PLANNING, ZONING, & BUILDING DEPARTMENT  
PZ&B Staff Combination Memorandum: Town Council and Architectural Commission

SUBJECT: ZON-24-0087 (COA-24-0032) - THE BREAKERS CENTRAL PARK PARKING GARAGE

MEETING: FEBRUARY 12, 2025 TC  
FEBRUARY 19, 2025 LPC

The applicant has submitted plans, entitled "THE BREAKERS PALM BEACH CENTRAL PARK", as prepared by **Hart Howerton**, dated and uploaded to the Town on January 28, 2025.

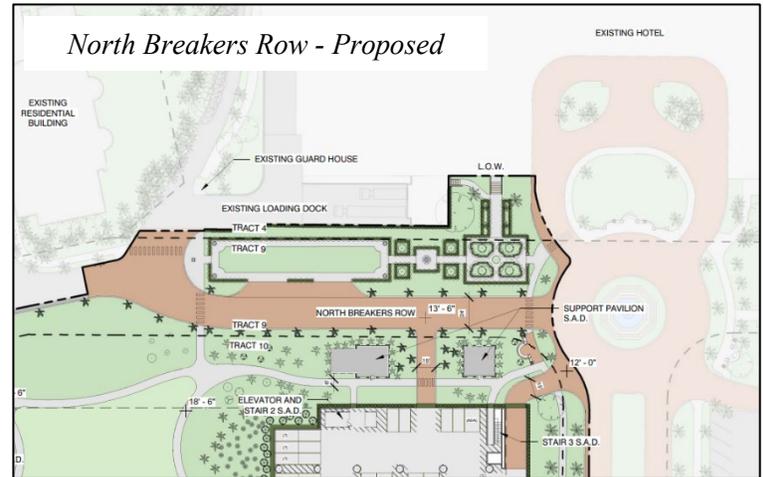
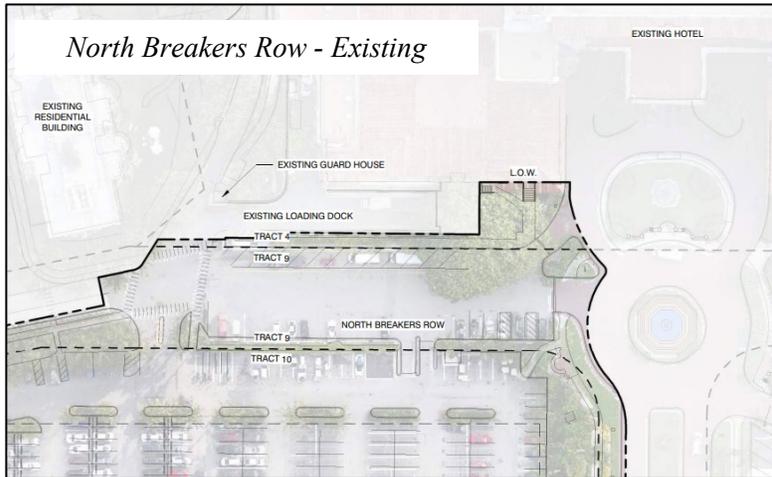
which serves overnight guests, day visitors, and staff. The existing parking lot is approximately 4 acres. It will be redeveloped as the ‘Central Park’ subterranean parking (218,727 square feet) and one at-grade surface-level parking area (79,808 square feet). The number of parking spaces will increase from 550 to 849. On the at-grade surface level, 124 tandem parking spaces are proposed which will require a variance, further discussed in the variance analysis section of this memorandum.

Improvements to North Breakers Row are proposed. There will be a reduction in the paved road width to accommodate a series of parterre gardens, west of the hotel building.

*Elevator & Stair Building*

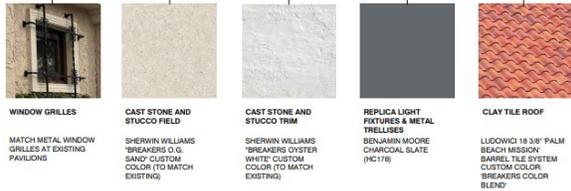
The scope of work includes a new support pavilion, elevator and stair building, fire pump building, electrical building, and central plant building. These buildings are designed to be compatible with other support structures on the property which draw inspiration from Mediterranean Revival architecture. The clay tile roofs, stucco finish, color palette, and architectural detailing are consistent with this style.
